Title:	RN Two-Wire IP Intercom v1.4.45 v2.0.0 061219NA	Version:	v1.4.45, v2.0.0	Date:	061219
Product:	DS-KH8340-TCE2 and DS-KV8103-IME2	Build:	190410	Page:	1 of 5
Action Required:	None, Information Only

Firmware for the following products have been updated to add new features:

Device Model	Firmware Versions and Builds
DS-KH8340-TCE2	v1.4.45_190410
DS-KV8103-IME2	v2.0.0_190410

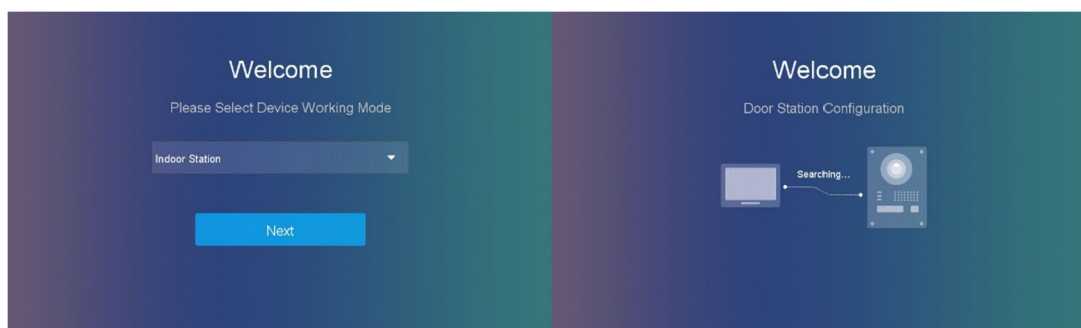
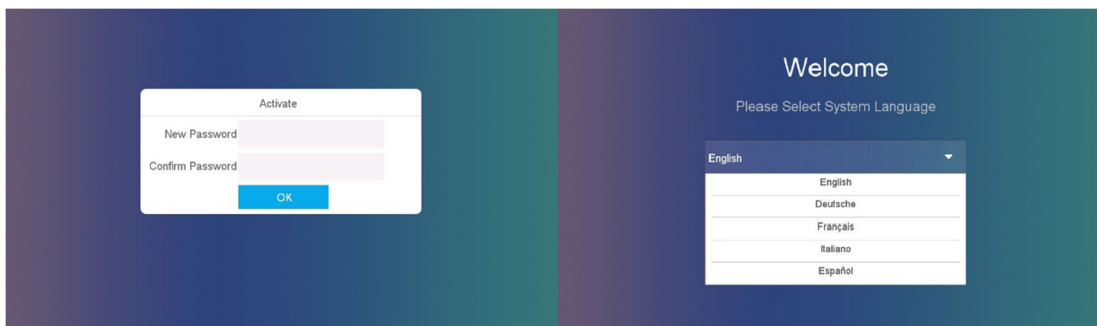
- DHCP bug was fixed by changing the synchronization mechanism between indoor and outdoor stations.
 - > When DHCP was enabled on the door station, the IP address could only be changed once.
 - > When DHCP was disabled on the indoor station, the IP could be changed more than once.

Main Indoor Station

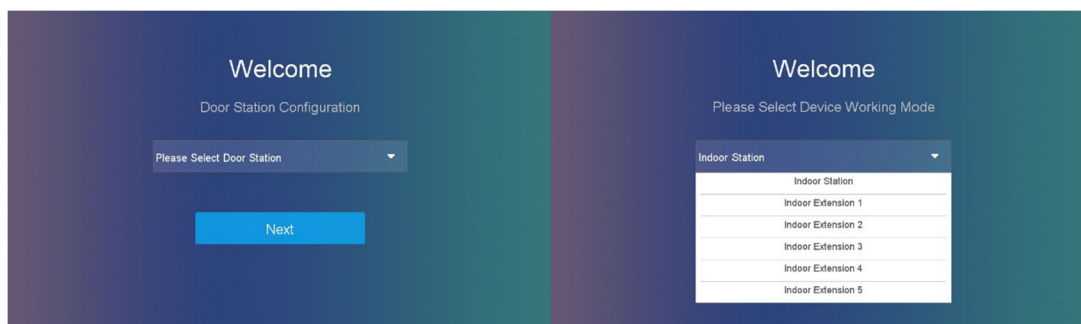
- Eight languages supported: English, Italian, German, French, Spanish, Polish, Dutch, and Czech
- One indoor station and five indoor extensions supported. Indoor extensions (room number extensions range: 1-5) can call each other by dialing the room number.
- Plug-and-play supported (simple configuration can be completed on indoor touch screen without using external PC software). Once the indoor station is turned on, the user will be asked to follow these steps: **Activation → Select Language → Select Indoor Station Type** (main indoor station or indoor extension).
 - > For Indoor Station: **Add Door Station → Active Door Station → Synchronize to Door Station.**
 - > For Indoor Extension: **Add Main Indoor Station.**
